# Harbourside Stage 1 DA

## Supplementary Architectural Design Report

**fjmt studio** architecture interiors urban landscape community  
Sept 2020 – SSDA1 SADR – Rev 05

This report provides a response to submissions (as relevant) and assessment of the proposed amended Concept Proposal in relation to the State Significant Development (SSD) Development Application (DA) for the redevelopment of the Harbourside Shopping Centre (SSD 7874).

**Previous Scheme (March 2020) vs Proposed Scheme (September 2020)**

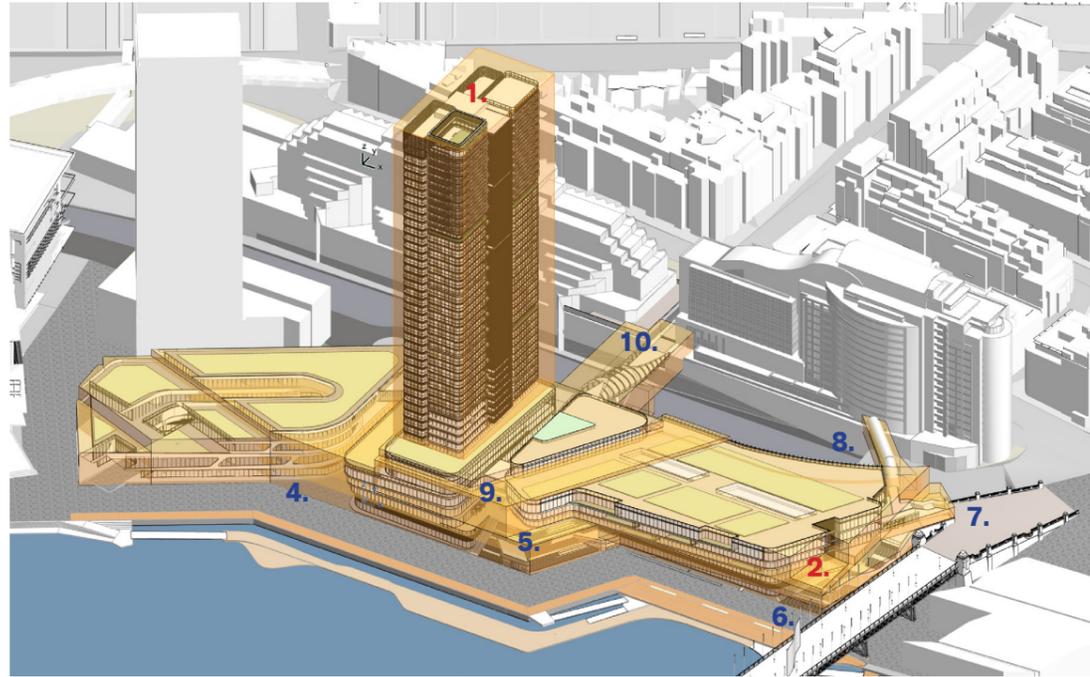
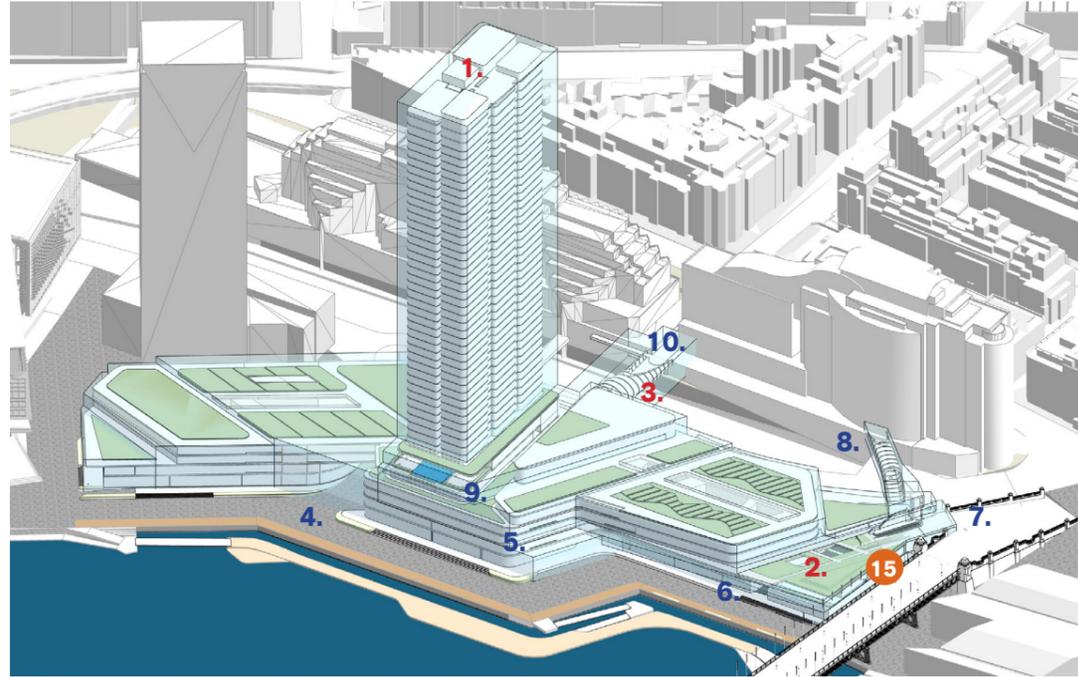
**Envelope (March 2020)**

Tower Envelope Height RL 153.75

North podium envelope RL 25.00

Recess in west podium envelope adjacent to Bunn St

**Envelope (September 2020)**

Tower Envelope Height increased to RL 166.95m

North podium envelope height reduced to RL 13.75

Recess in west podium envelope adjacent to Bunn St removed - No impact on views and shadows (See envelope plan)

Key Issues as nominated in DPIE letter ref:SSD 7874

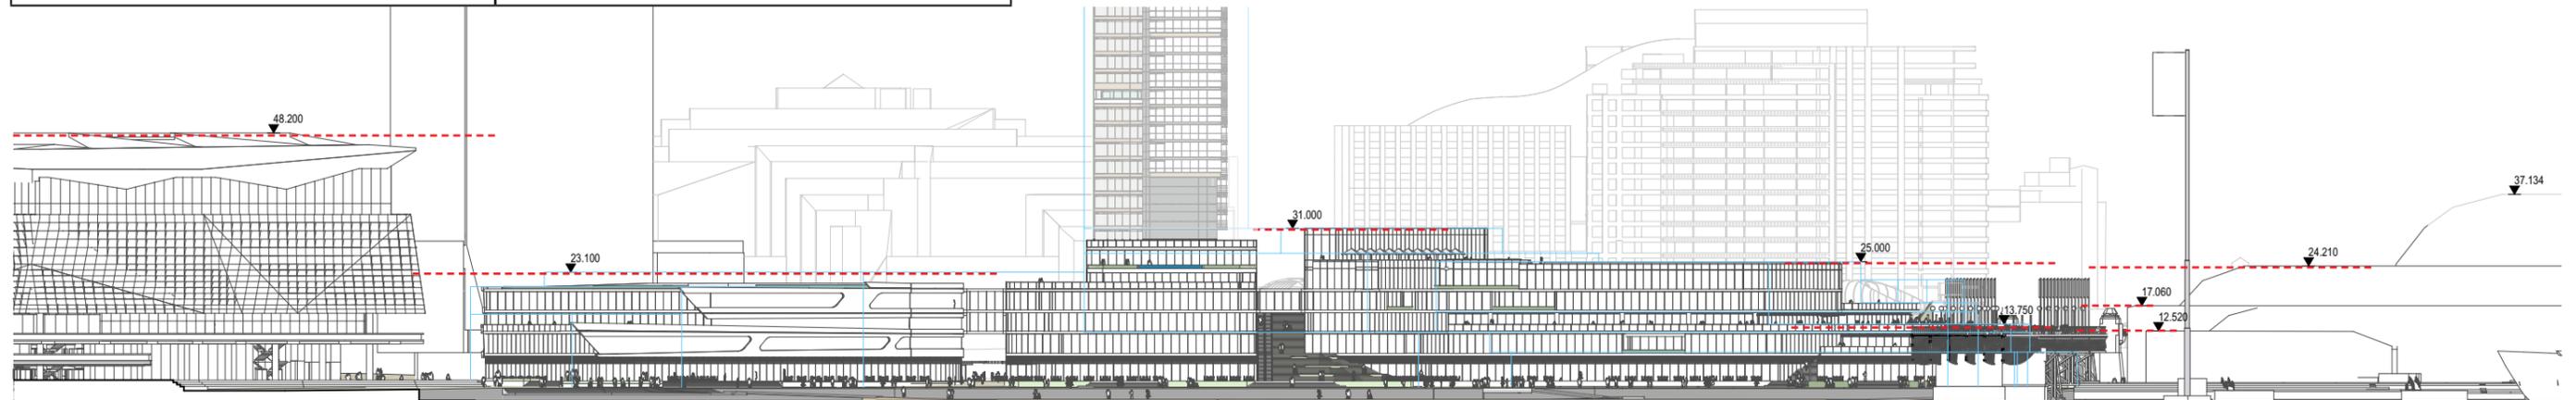
Key Issue 1: Northern Podium	Response to Issue
<p>The Department supports lowering the height and increasing the setbacks of the northern podium as presented to the Department at the meeting of 28 July 2020 to:</p> <ul style="list-style-type: none"> <li>— improve its relationship with Pyrmont Bridge</li> <li>— provide the opportunity for a significant area of publicly accessible and usable open space on the podium roof</li> <li>— reduce view impacts to 50 Murray Street.</li> </ul> <p>The Department notes this space is set out over a number of levels and includes stairs, ramps and the like which may limit its function as quality public open space. The Department requests that you demonstrate that a sufficient area of functional and usable public open space can be delivered on the lowered northern podium.</p> <p>The Department also requests that you demonstrate that view impacts to 50 Murray Street are equivalent to that shown at the second meeting on 7 July 2020.</p>	<p>The proposal seeks to further refine the northern podium built form to respond to the issues identified by the Department. Key improvements relative to the previous submission include:</p> <ul style="list-style-type: none"> <li>— Reduction of the height of the northern end of the podium adjacent to the Pyrmont Bridge</li> <li>— Provision of a generous and functional public open space</li> <li>— Increase setback of the built form above Pyrmont Bridge level up to 41m.</li> <li>— Retail envelope setback 7m below bridge level (currently 4m)</li> <li>— Improved view sharing to Pyrmont Bridge from adjacent residences</li> <li>— Upgrading of paving to entry to bridge</li> </ul> <p>These key improvements are addressed in detail in the pages to follow.</p>

The northern podium height is considered sympathetic to the adjacent Pyrmont Bridge and its built form is consistent with the Maritime Museum to the north of the Pyrmont Bridge.
